Notice of Allowability

10/689,393

BOURQUE ET AL.

In re Appln. of: Jeffrey Gerard Bourque, et al.
Appln. No. 10/588,383 filed October 20, 2003
For: Panel Assembly for a Motor Vehicle
Attorney Docket No.: 10541-1881

Fig. 4

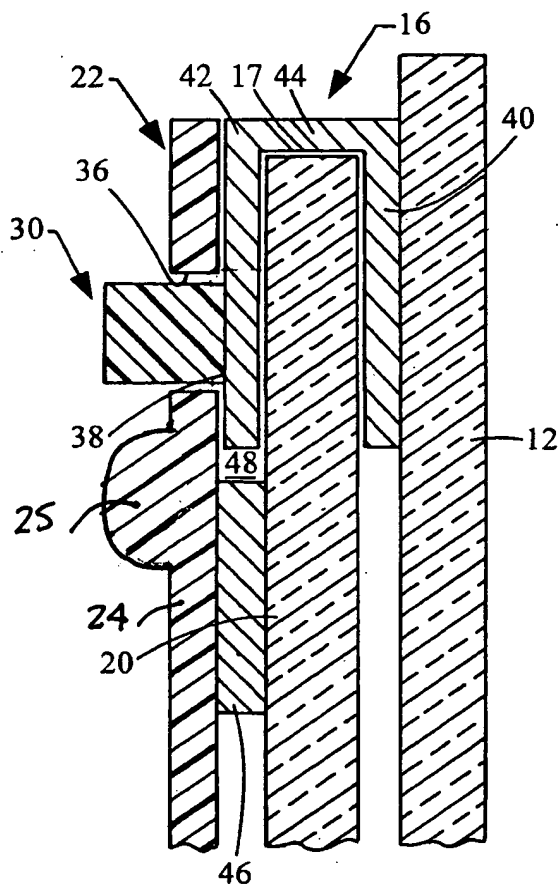
The proposed drawing changes dated 11/1/2005 are not approved by the Examiner. Attached are proposed drawing changes made by the Examiner and approved by the attorney of record. The following changes are shown in red: In Figures 4 and 6, element 25 has been added, and Figure 7 has been added.

Fig. 6

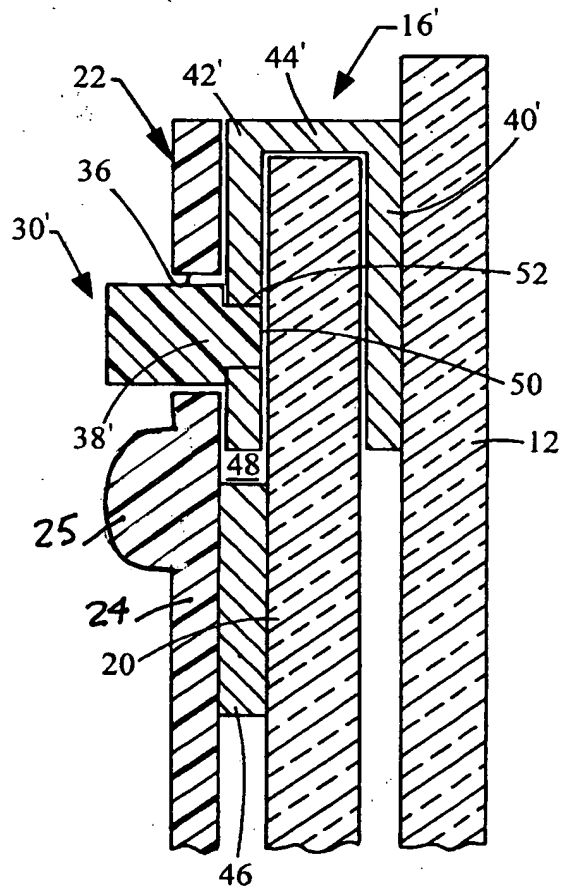
In paragraph [0027], line 4, "52 (FIG. 6)" has been deleted; and

Fig. 7

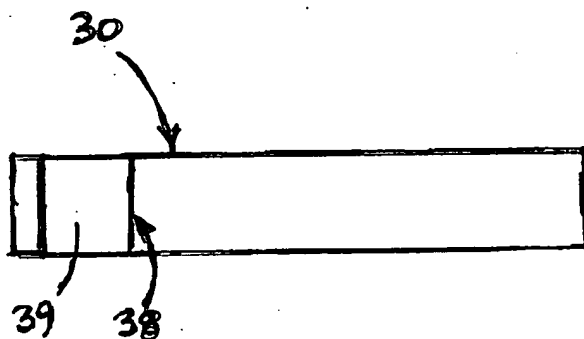
--FIG. 7 is a plane view of the cam depicted in Figs. 1-4.--

--(39, Fig. 7)-- has been inserted after "teeth".
